Campaign No. 2020100015, November 2020

SUBJECT: **Model GLE-Class and GLS-Class vehicles (167 platform)**
Model Year 2020
Installation of the Illuminate Star

Figure 1

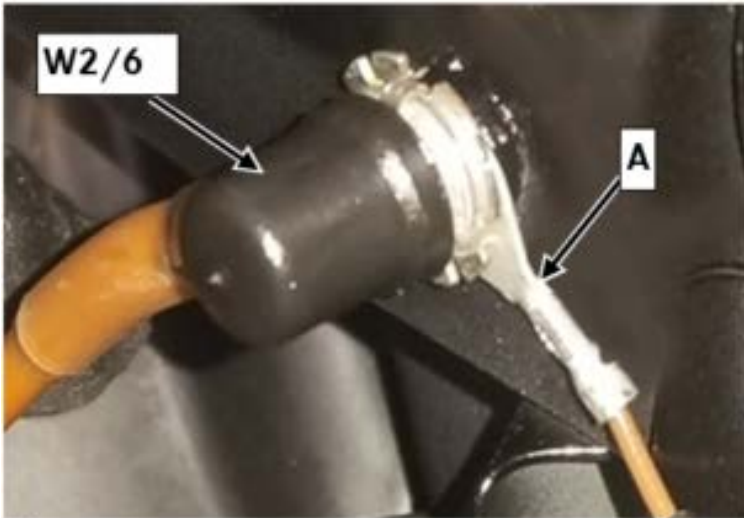
1. Open hood.
2. Switch off ignition and store transmitter key outside the transmitter range (at least 2 meters).
3. Unscrew ground **point W2/6**.
i For basic data, see **GF00.19-P-2001-17NCA**.
4. Remove illuminated star ground line (**A, figure 1**).

6. Route illuminated star ground line (**A, figure 1**) to jump-start connection point and attach to threaded pin of jump-start connection point.
7. Screw on brass sleeve (**B, figure 2**).
Nm Brass sleeve **16 Nm**.
8. Secure illuminated star ground line (**A, figure 1**) up to jump-start connection point.
i Ensure a chafe-free routing and attachment of the illuminated star ground line See **AZ88.40-P-0011-01ME**
9. Check anti-twist protection (**C, figure 3**) of cable lug of ground **point W2/6** for damage.

Figure 3 (OK)

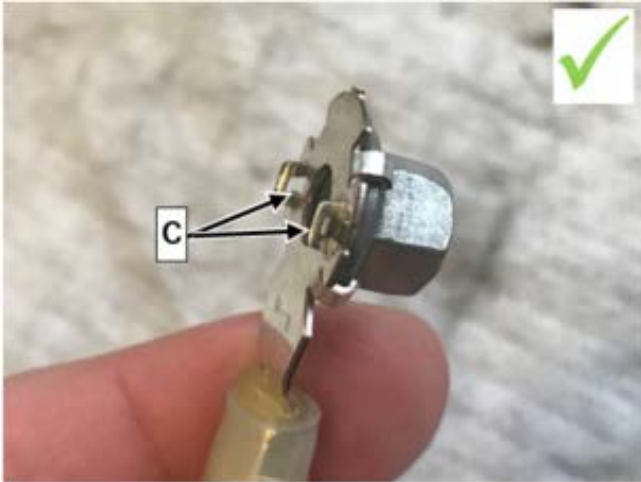
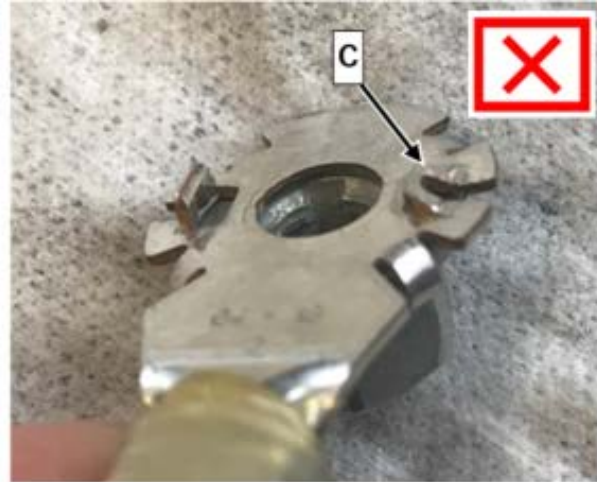
- a. Anti-twist protection (**C, figure 3**) **straight** or **bent outwards**, i.e. outside dimension between anti-twist protection lugs (**D, figure 4**) **equal to or greater than 13.6 mm**: Perform operation step 11, then **end measure**.
- b. Anti-twist protection (**C, figure 3**) **bent inwards**, i.e. outside dimension between anti-twist protection lugs (**D, figure 4**) **less than 13.6 mm**: Create **PTSS case**.

Make detailed photos of anti-twist protection of ground line, ground point W2/6 in removed condition. Clarify the further repair procedure via a **PTSS case**. Keep faulty part.

Figure 4

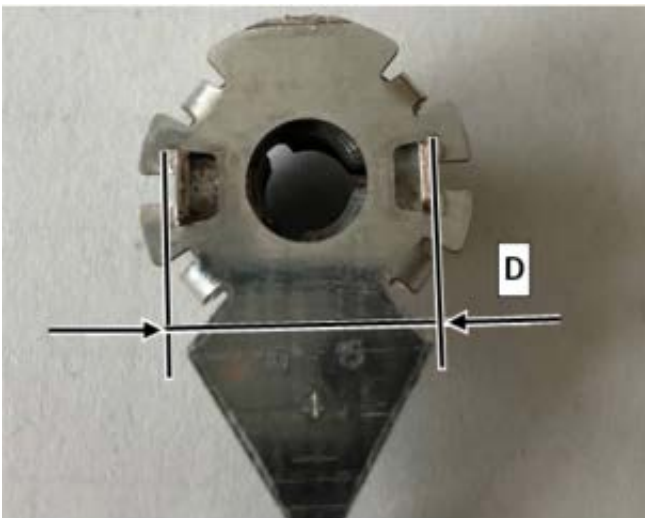
10. Measure outside dimension between anti-twist protection lugs (**D, figure 4**).
i Outside dimension between anti-twist protection lugs (**D, figure 4**) **min. 13.6 mm**.

i Only if anti-twist protection of cable lug is **bent inwards** , i.e. outside dimension between anti-twist protection lugs (**D, figure 4**) is **less than 13.6 mm**.
